NOTICE OF NON-PERFORMANCE

INSPECTION REPORT

Electrical Corporation:	PacifiCorp
Report Number:	PAD_PC_IAG_20251007_1041
Inspector:	Ivan Garcia
WMP Year Inspected:	2025
Quarterly Data Report (QDR) Referenced:	Quarter 2 (Q2)
Inspection Selection:	Energy Safety viewed the contents of the Q2 QDR and performed an analysis that resulted in the selection of the WMP initiatives and locations referenced in this report.
Relevant WMP Initiative(s):	8.1.2.12 - Expulsion Fuse Replacements
Date of inspection:	October 07, 2025
City and/or County of Inspection:	Montague, Siskiyou County
Inspection Purpose:	Assess the accuracy of PacifiCorp's QDR data, completeness of its work, and performance of WMP requirements.

GImg1: Overall Structure	GImg2: No Structure ID

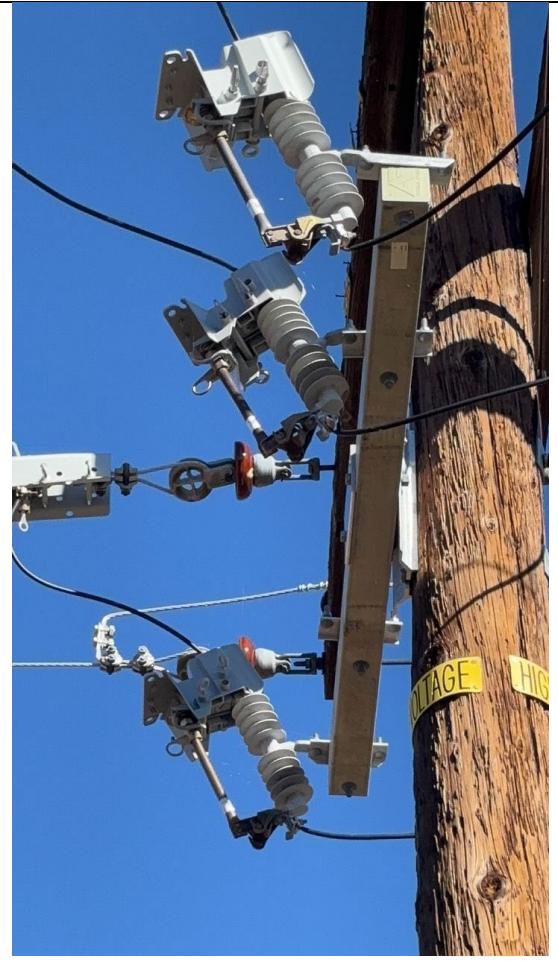
1. CAL FIRE-approved non expulsion fuses were not installed at the subject pole.
2. The inspector observed solid blade disconnects on the subject pole.
3. No reclosers, sectionalizers, or voltage regulators were observed at the subject pole.

IA1Img1: Solid blade disconnects installed

Deficiency 1. Energy Safety observed that in implementing 2025 WMP initiative 8.1.2.12 - Expulsion Fuse Replacements, PC failed to complete the installation of CAL FIRE-approved non expulsion fuses on a pole with work associated with Grid Hardening ID 7112939 at coordinates 41.71135922538462, -122.59285126282776. Energy Safety considers this non-performance to be in the Minor risk category. PC must complete a corrective action for this deficiency by 12 months from date of this notice.¹
